MATANUSKA-SUSITNA BOROUGH

PLATTING BOARD MEETING

March 6, 2025

PRELIMINARY PLAT: GREENFIELDS 19-1
LEGAL DESCRIPTION: SEC 19, T18N, R01W, SEWARD MERIDIAN AK
PETITIONERS: MATTHEW ESTRADA
SURVEYOR/ENGINEER: HANSON LAND SOLUTIONS/PIONEER ENGINEERING LLC
ACRES: 5.77 ± PARCELS: 5
REVIEWED BY: WYATT ANDERSON CASE #: 2025-005

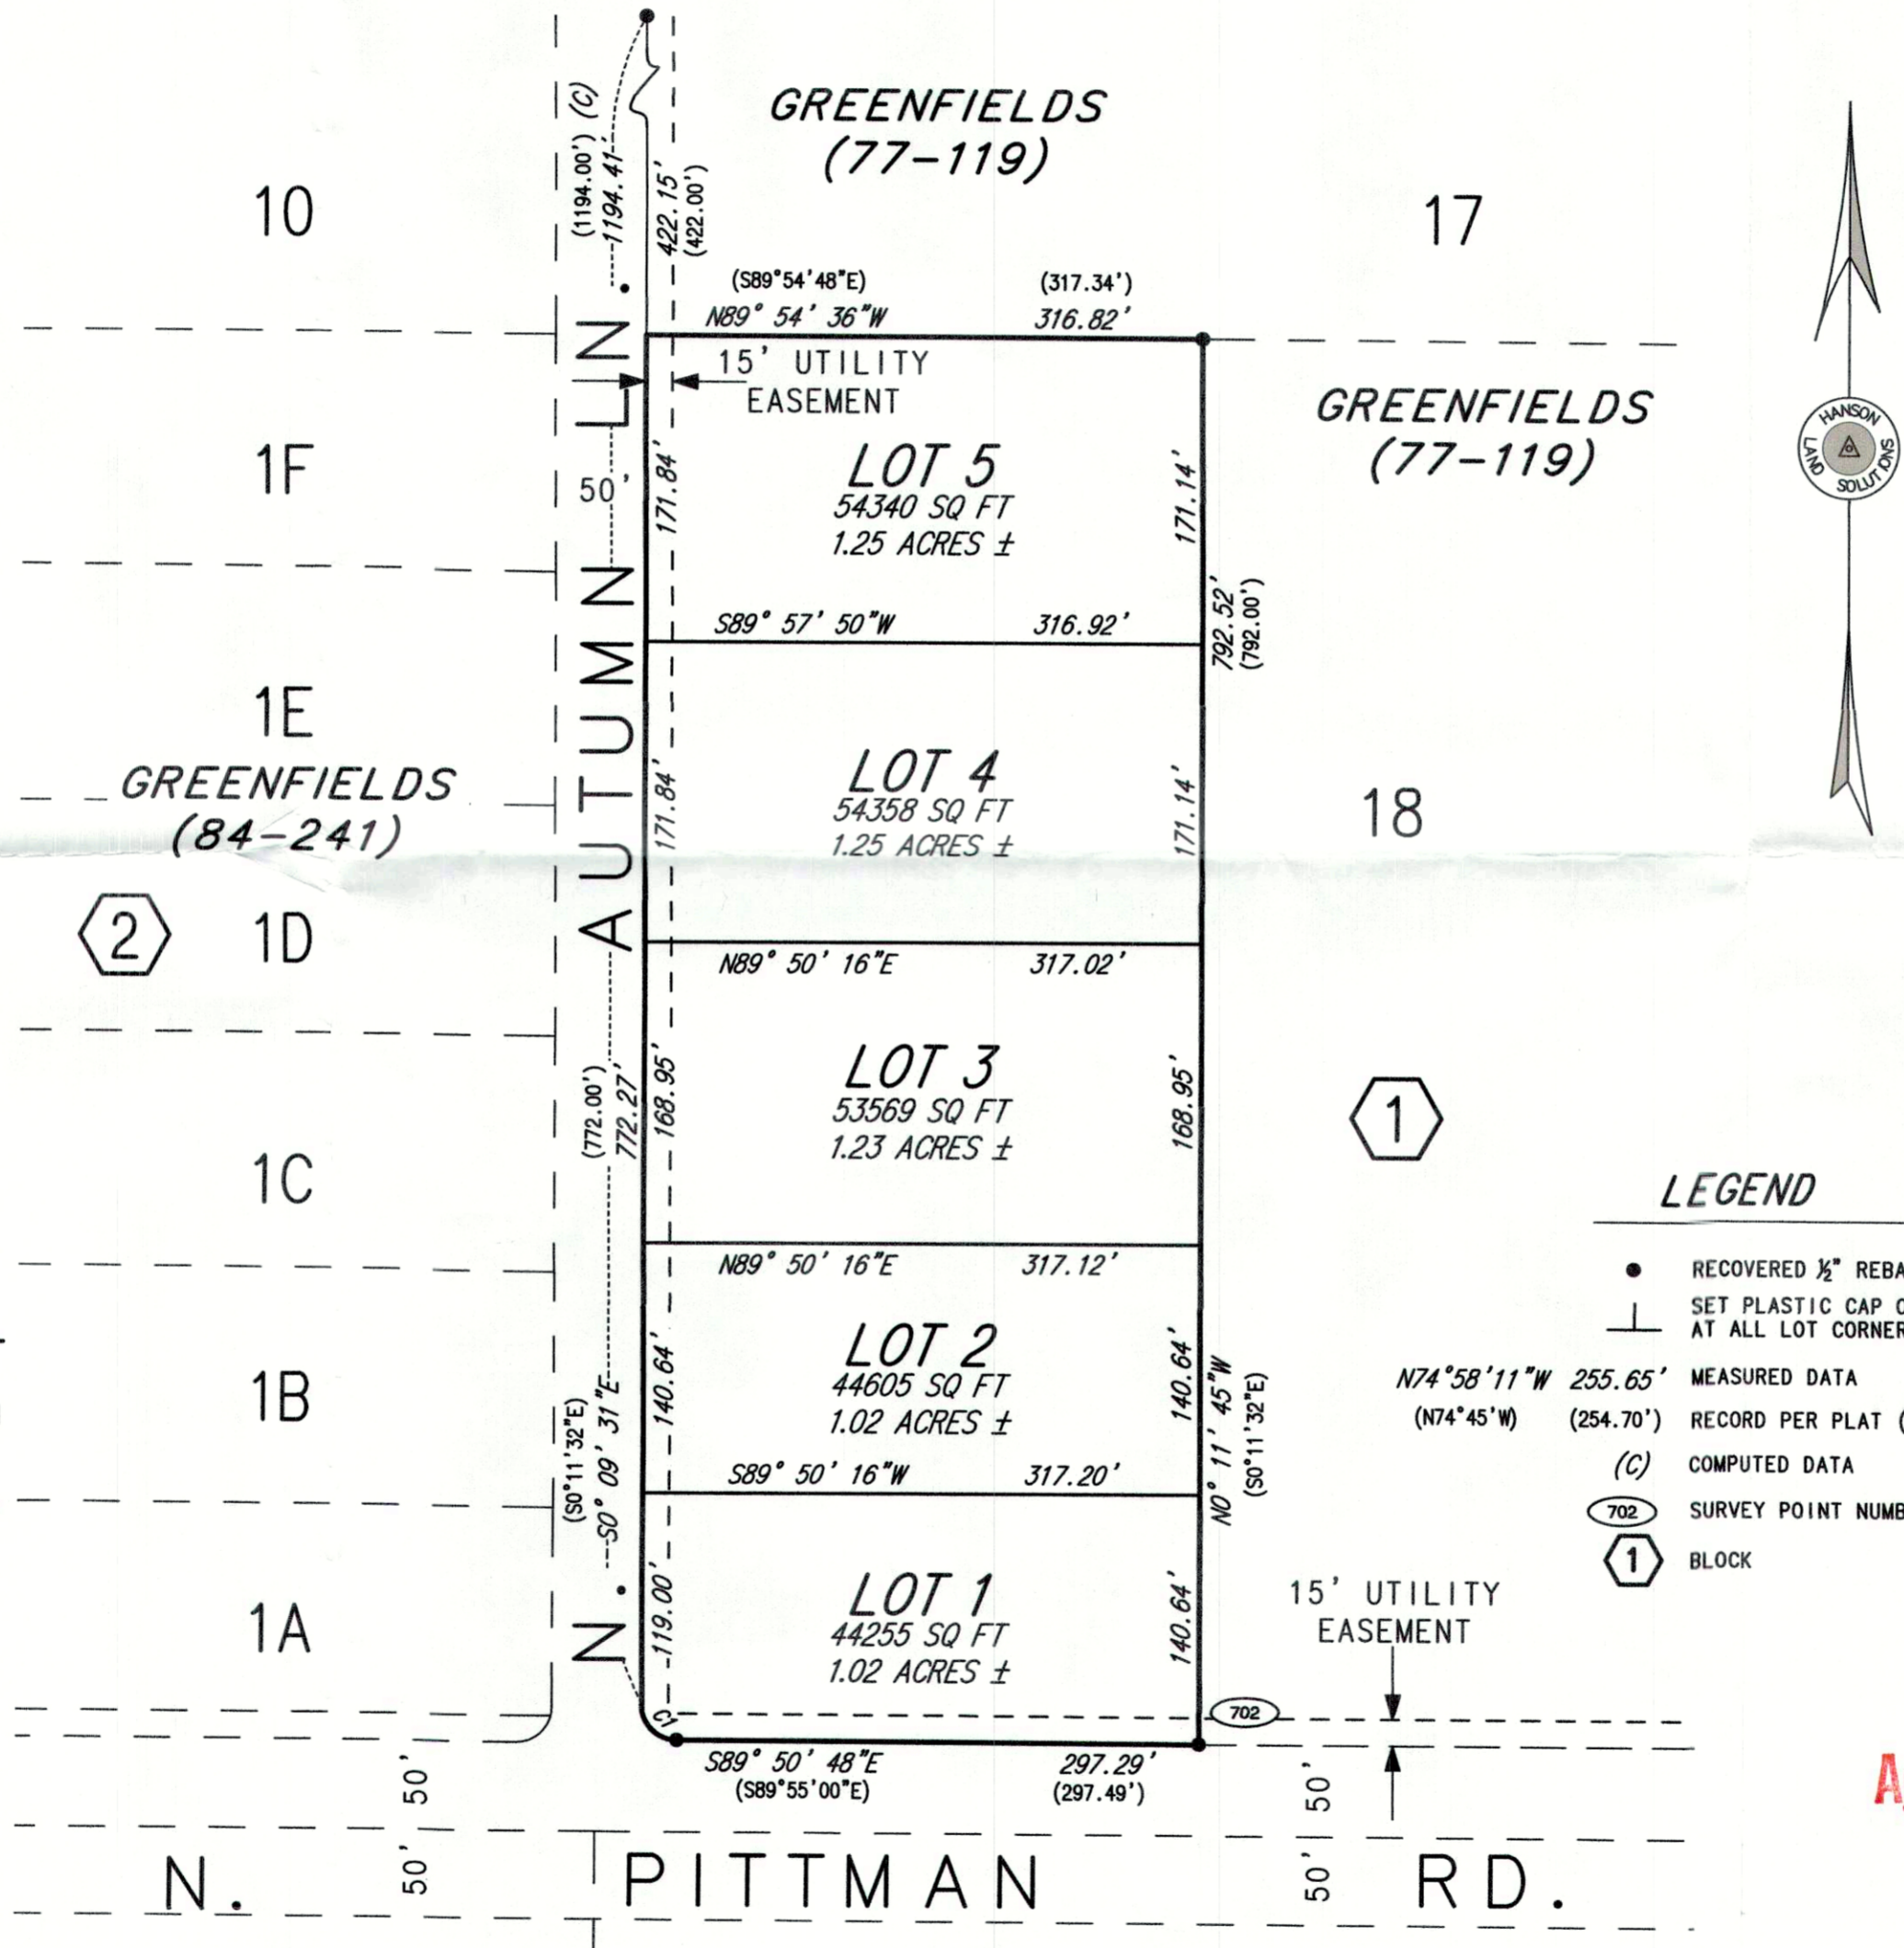
ADOT&PF (**Exhibit Pages 19-21**) has no objections to the proposed design, but has the following comments:

- All lots to take access from N. Autumn Lane.
- See (*Staff Recommendation #4*)
- Subsequent development and subdivision of Lot 1 will require continued access through N. Autumn Lane.
- No New utility connections through Pittman Road or Pittman Road right of way
- Please be advised that this plat is within the boundary of DOT&PF project HSIP: Pittman Road Shoulder Widening and Slope Flattening, which may affect Lot 1.

MSB Development Services (**Exhibit Page 22**) has no objections with the proposed subdivision, but notes that, "Access to Lot 1 should be restricted to Autumn Lane. Pittman road is a Major Collector, and no new access points should be established to maintain traffic flow and safety. Additional access points contribute to congestion and increase the risk of accidents." (*Staff Recommendation #4*)

1. Taxes and special assessments must be paid in full for the year of recording, pursuant to MSB 43.15.053(F) and AS 40.15.020. Pay taxes and special assessments (LIDs), by CERTIFIED FUNDS OR CASH.
2. Provide updated Certificate to Plat executed within seven (7) days of recording of plat and submit Beneficiary Affidavit for any holders of a beneficial interest.
3. Pay postage and advertising fees.
4. Add Plat Note, "No direct access from Lot 1 to Pittman Road."
5. Show all easements of record on final plat.
6. Submit recording fees, payable to Department of Natural Resources (DNR).
7. Submit plat in full compliance with Title 43.

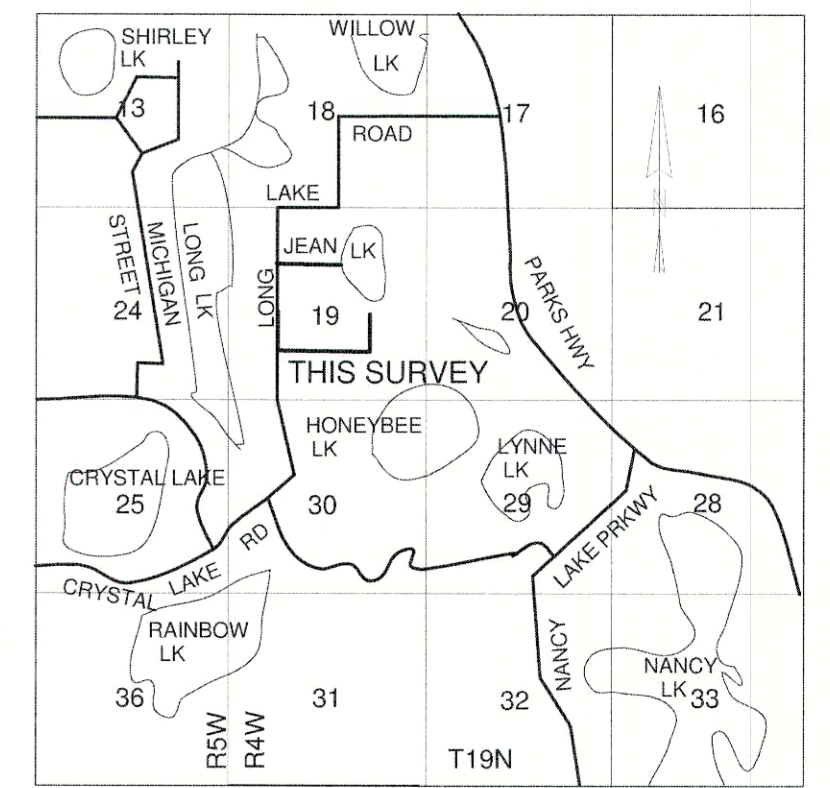
- DOT&PF will permit two access points to Long Lake Road – one for subdivision and one for Lot 4 and 4B, please plan accordingly.
- Add plat note: “No direct access to Long Lake Road for Lot 30, 31, 32, 1, 2, 3, and 4.”

MSB DPW Pre-design and Engineering (**Exhibit D**) The ADT estimate looks acceptable. The comments I sent earlier today regarding drainage stand: According to SCM D02.1, show the ordinary high water mark on the drainage plan with a 100' upland offset. Provide a more detailed drainage plan showing proposed cross culverts, drainage arrows on all lots, and proposed drainage basins. Show proposed drainage easements on the plat. A large portion of runoff from the site appears to drain onto the north west corner of Lot 4 and then be detained in the natural basin. Show proposed drainage easement on Lot 4 for where the water is expected to be detained and provide a drainage path outlined in the drainage plan for the runoff to reach here.

3. Submit a drainage plan compliant with SCM D02.1
4. Construct interior streets and cul-de-sac to Residential Street standard according to the 2022 Subdivision Construction Manual (SCM):

- e) Submit as-built of streets and drainage improvements to Platting staff once construction is complete.
5. Add plat note: "No direct access to Long Lake Road for Lot 30, 31, 32, 1, 2, 3, and 4."

6. Dedicate a common access easement for lots 4 and 4B.
7. Pay postage and advertising fees.
8. Show all easements of record on final plat.
9. Submit recording fees, payable to Department of Natural Resources (DNR).
